# TECHNICAL NOTE

JBA Project 2017s6312 - Caerleon Road, Dinas Powys  
Client Kier Living Ltd  
Day, Date and Time 28 July 2017  
Author Daryl Taylor  
Subject Caerleon Road, Dinas Powys – Surface Water Drainage Review

**Figure 4: Exceedence Model Results (Including Direct Rainfall)**

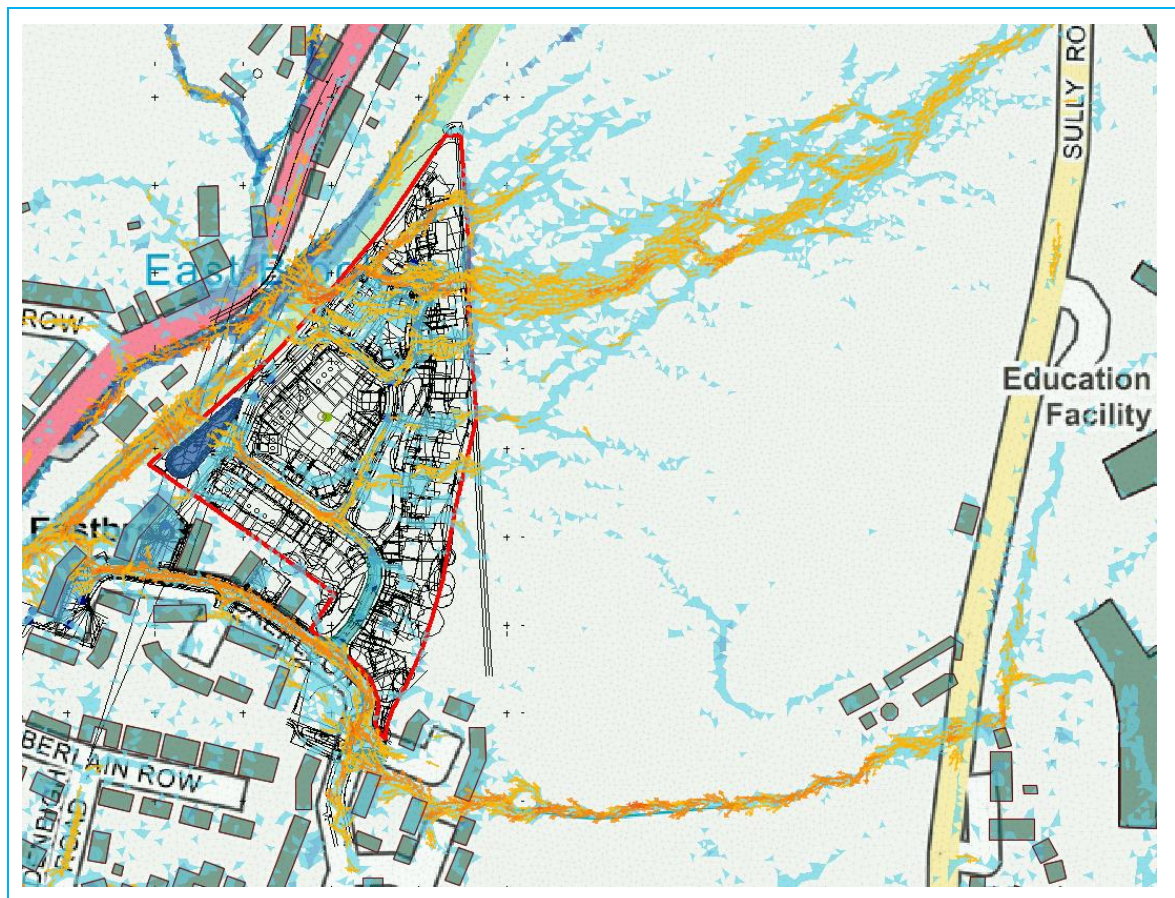
Figure 4 shows the effect of surcharging flows during a storm event. In the northern portion of the site flows from adjacent land are shown to cross the development site including in the location of proposed dwellings. Where overland flows are shown to intercept the location of a proposed dwelling, building thresholds will be raised at least 300mm above surrounding ground levels to reduce the risk of flooding. Additionally, levels along the eastern boundary will be raised along the western edge of the existing drainage ditch, in order to improve its ability to intercept overland flows and direct them to the East Brook at the northern corner of the site, which will reduce the risk of flooding to both the site and the railway line.

Mitigation measures to reduce the risk of on-site flooding from shallow overland flows from neighbouring fields to the east have been proposed. The finished floor level of all proposed dwellings intercepted by the overland flow routes will be raised at least 300mm above local ground levels, and ground levels along the western edge of the existing drainage ditch along the eastern boundary will be increased to intercept overland flows before entering the site, directing these instead to the East Brook upstream of the railway to reduce flood risk to the site and the railway line.
